# Indoor Station Firmware V2.2.20\_build230601

## Release Note (2023-06-06)

Device Model	DS-KH8350-WTE1, DS-KH8350-TE1, DS-KH6320-WTE1, DS-KH6320-TE1, DS-KH6320-WTE2, DS-KH6320Y-WTE2, DS-KH6320EY-WTE2, DS-KH6320-WTE2(B), DS-KH8520-WTE1, DS-KH6320-WTDE1, DS-KH6320-TDE1
Firmware Version	V2.2.20_build230601
iVMS-4200	V3.9.1.4 or later

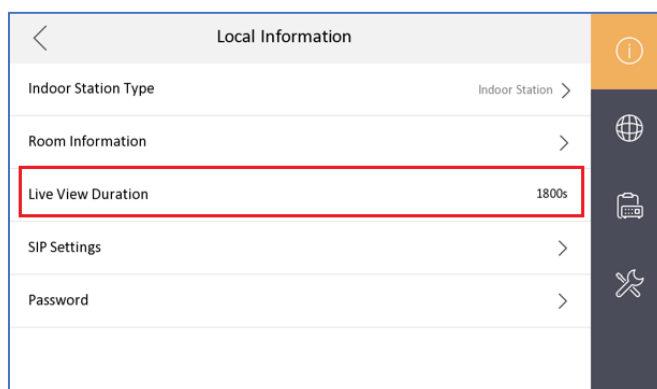
1. Optimized the icon of door station registration status in the main UI up right corner.

*Note:* If the door station call indoor station failed, you can click this icon  to register to door station manually, if register failed, it will indicate the reason for the failure.

Before	Now
Indoor station registers to door station success		
Indoor station registers to door station failed		
Indoor station registers to door station and KM9503 success

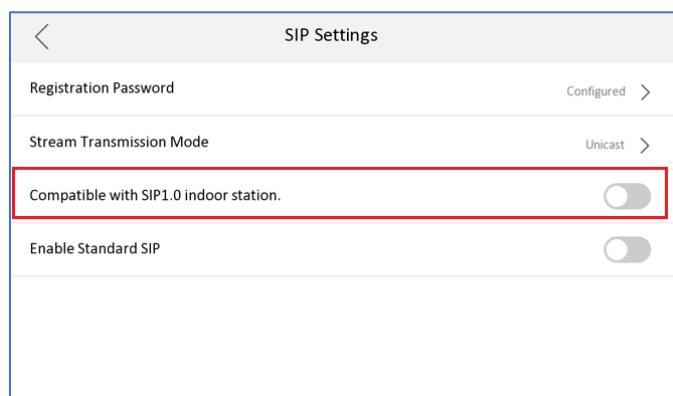
- Support switching between protocol 1.0 and 2.0, by default it's protocol 2.0. After enable, the indoor station is compatible with protocol 1.0 indoor extension and not compatible with protocol 2.0 indoor extension.

*Note: After enable, all indoor extension of this indoor station must be protocol 1.0 firmware, don't mix protocol 1.0 and 2.0 indoor extension under same indoor station, or it will result to calling failed.*

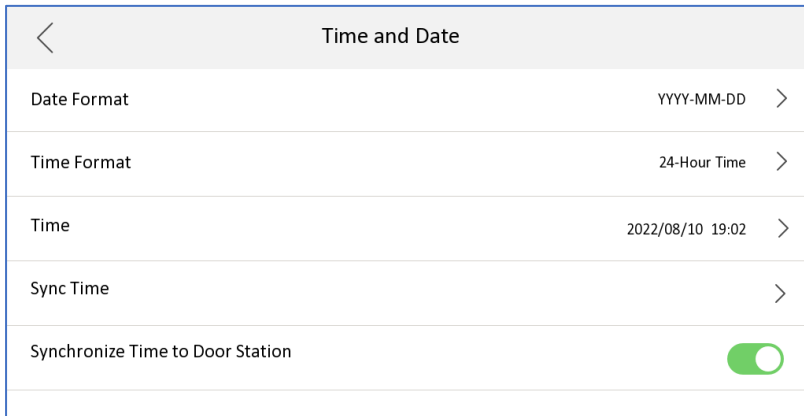
1. Supports static IP address configuration of Wi-Fi (DHCP, IP address, subnet mask, gateway, DNS1, DNS2).

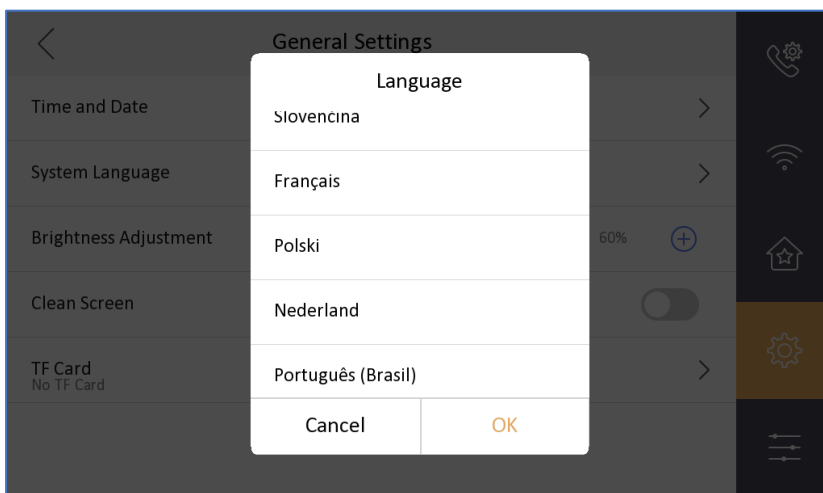
2. Supports configuring time and time zone for the door station.

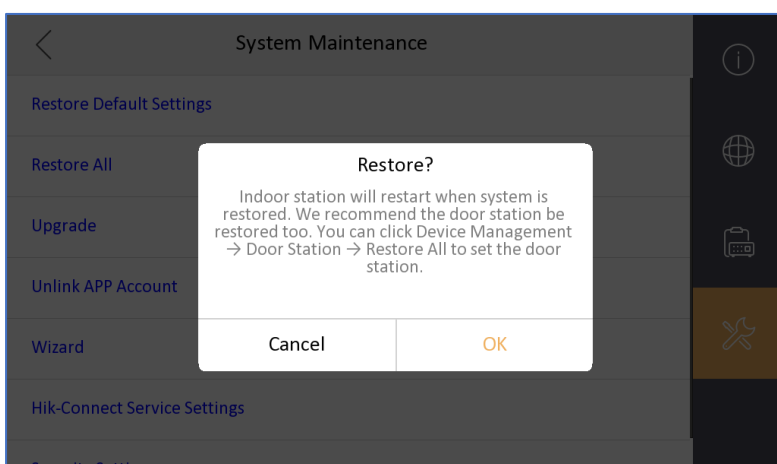
- 1. Optimizes the maintenance interface with a pop-up window when clicking **Restore** or **Restore All**.

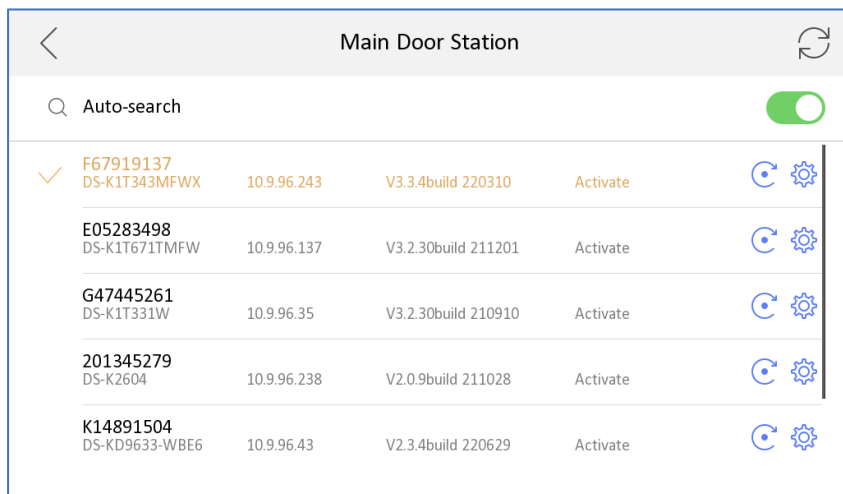
- 2. Adds the effect of selected door station when relating devices in wizard.

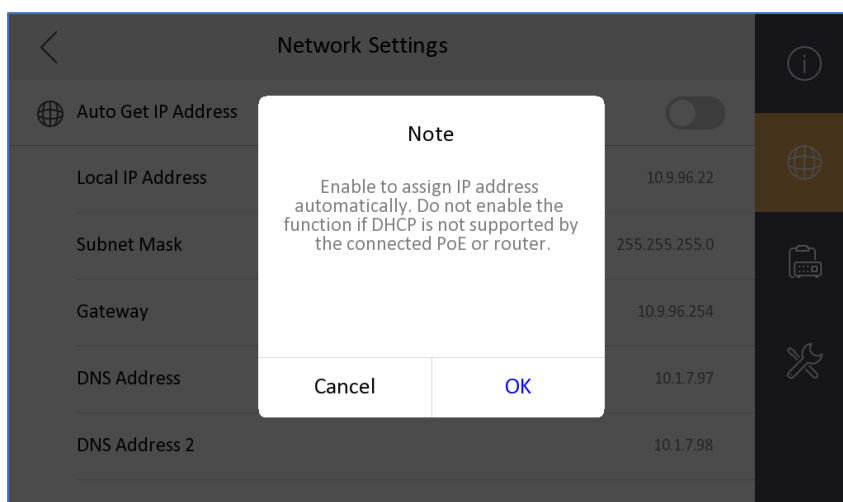
3. Adds a prompt when assigning network IP address automatically.

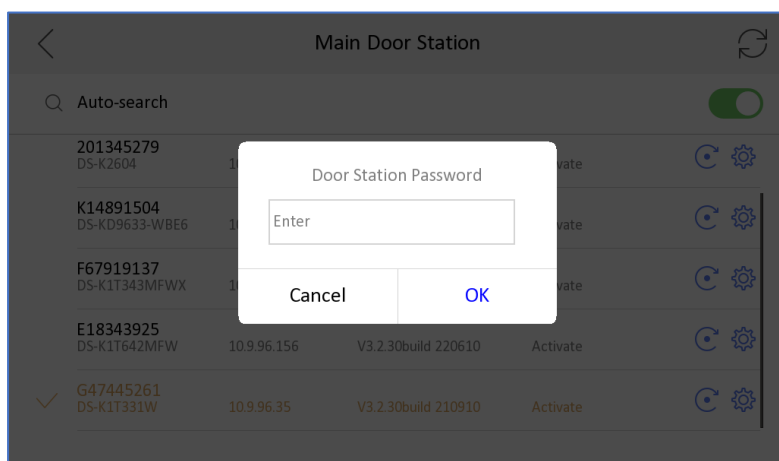
4. In configure wizard to related door station, when the door station password is different from the indoor station, prompt information will pop.

## Wizard-Indoor Station Settings 3/5

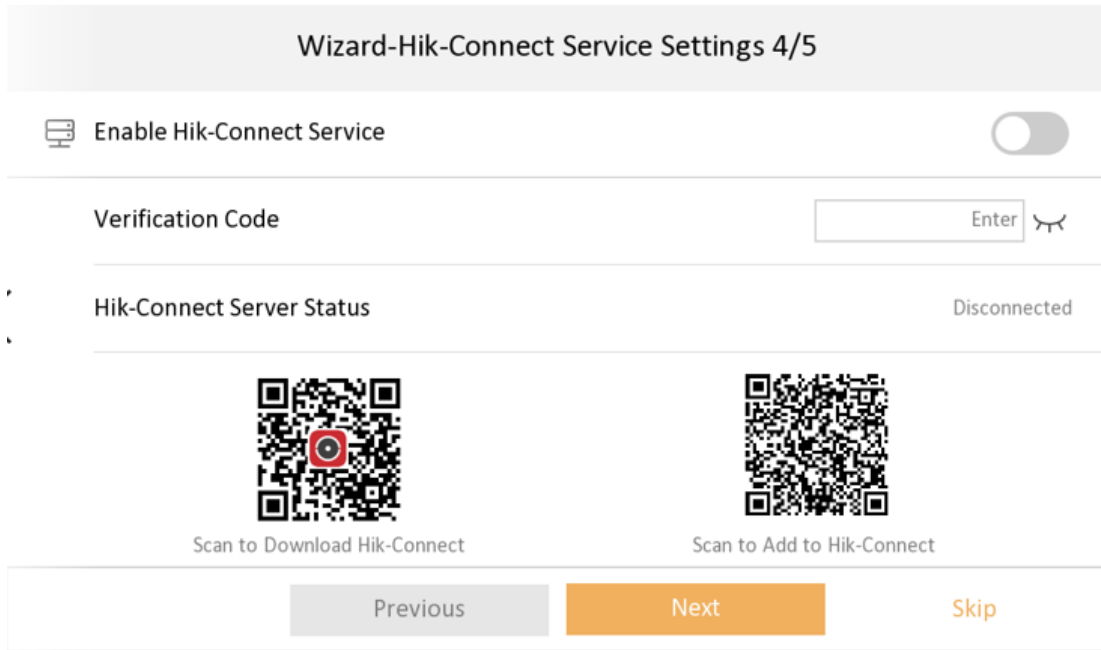
1. Optimize registration password settings in Wizard.

**Wizard-Hik-Connect Service Settings 4/5**

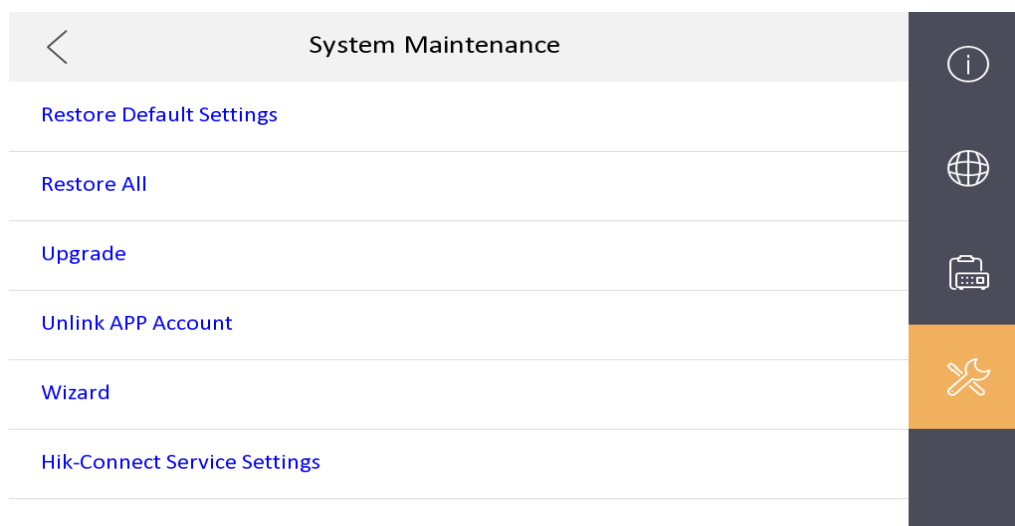
1. Verification code is empty by default.

**Add Device**

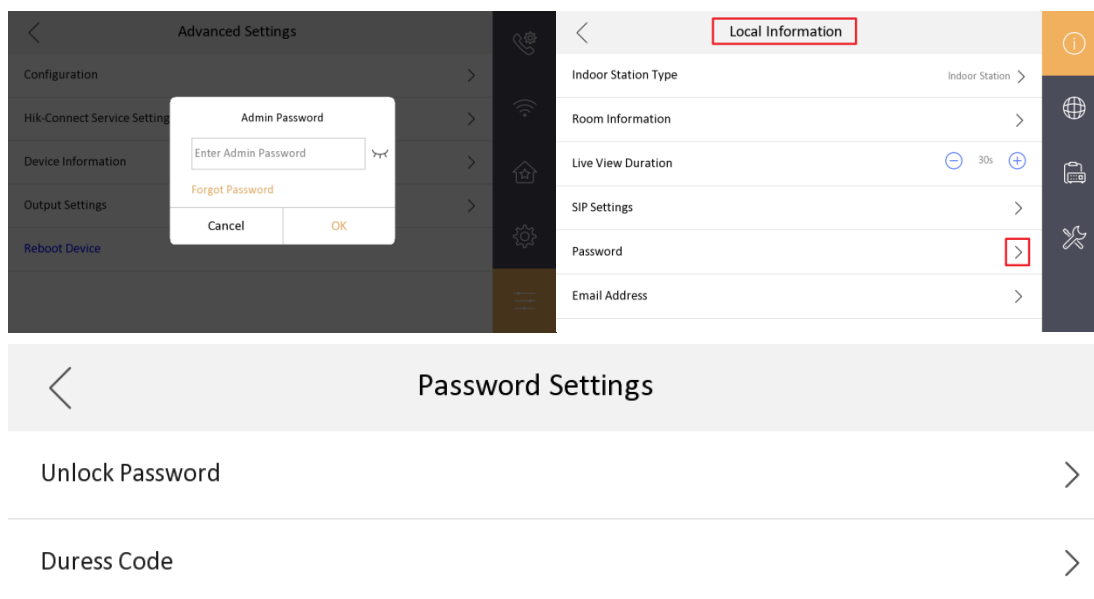
4. Add IPC interface, when Open Network Video Intercom protocol is selected, add plaintext ciphertext switch menu item configuration

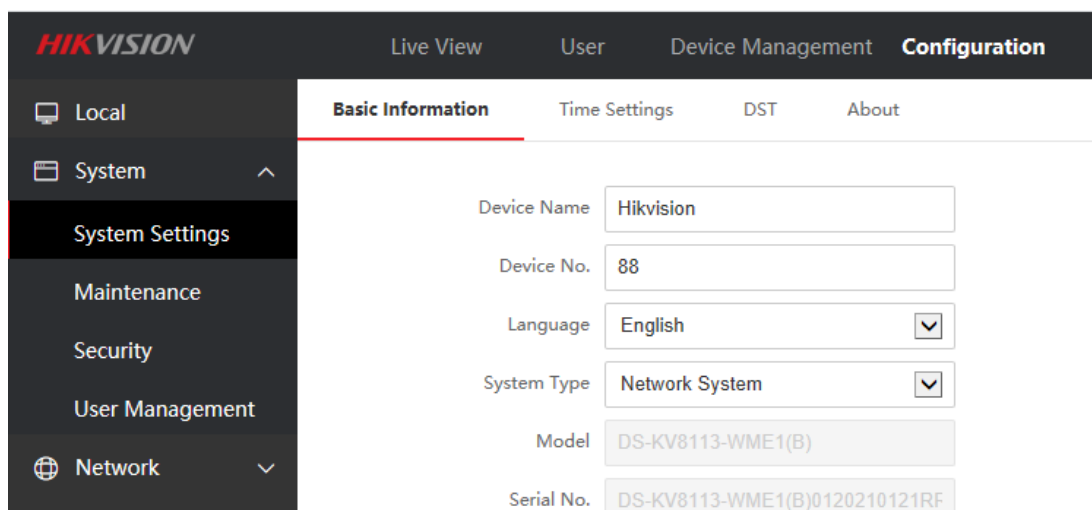
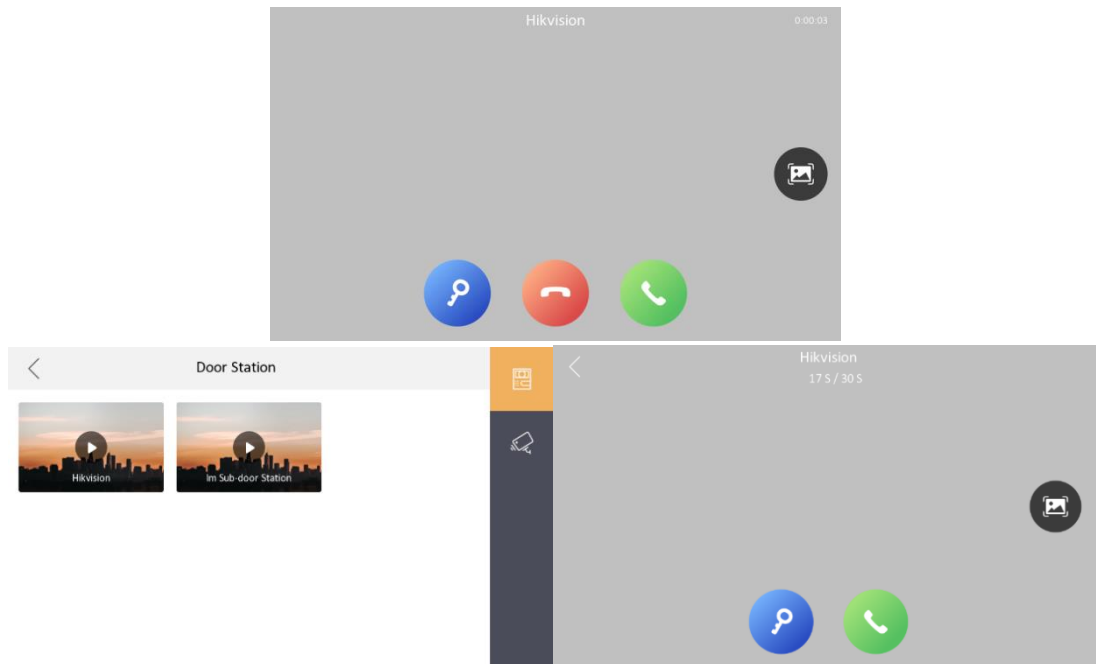
1. Change the position of unlock password and duress code, to enter the password page requires an admin (activation) password.
